Access Compliance Report

Public Rights-of-Way

Intersection ID: 10036624	Main Street: RUTAN_LN	Cross Street: ALLISON_FOREST_TR	Location: NW
ADA ID: 0B628757534C	Ramp Type: Perp	Initial Pass/Fail: Fail	Overall Compliance: No
Severity Score: 8.75			
Codes/Mitigation Info/Possible Solution		Field Measurements/Component Compliance

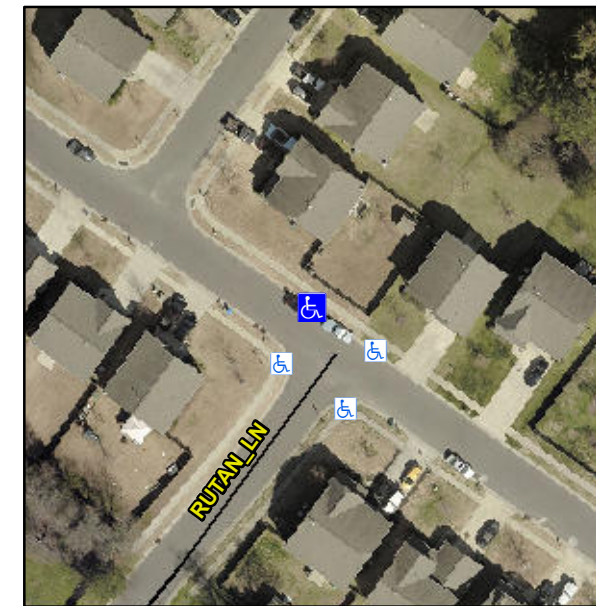
Not Found, R304.5.1

Compliance	Description	Data	Compliance	Description	Data
N/A	Ramp Length (in)	45.0	Yes	Ramp Slope (%)	6.1
No	Ramp Width (in)	47.0	Yes	Ramp XSlope (%)	0.1
N/A	Flare Type LT	N/A	N/A	Flare Type RT	N/A
N/A	Flare Slope LT (%)	N/A	N/A	Flare Slope RT (%)	N/A
N/A	Flare Traversable LT?	N/A	N/A	Flare Traversable RT?	N/A
N/A	Landing Length (in)	N/A	N/A	DWS Provided?	N/A
N/A	Landing Width (in)	N/A	N/A	DWS Contrast?	N/A
N/A	Landing Slope (%)	N/A	N/A	DWS Length (in)	N/A
N/A	Landing X Slope (%)	N/A	N/A	DWS Full Width?	N/A
N/A	Landing Curb? (Y/N)	N/A	N/A	DWS Offset (in)	N/A
N/A	Shared Landing?	N/A			
N/A	Gutter Ponding?	N/A	N/A	Gutter Slope (%)	N/A
N/A	Gutter Lip Ht (in)	N/A	N/A	Gutter X Slope (%)	N/A
N/A	Painted X Walk1?	No	N/A	Painted X Walk2?	N/A
	X Walk 1 Direction	To SW		X Walk 2 Direction	N/A
N/A	X Walk 1 Width (in)	N/A	N/A	X Walk 2 Width (in)	N/A
	X Walk 1 Slope (%)	3.2		X Walk 2 Slope (%)	N/A
	X Walk 1 X Slope (%)	0.5		X Walk 2 X Slope (%)	N/A

Remove & Replace Entire Ramp.
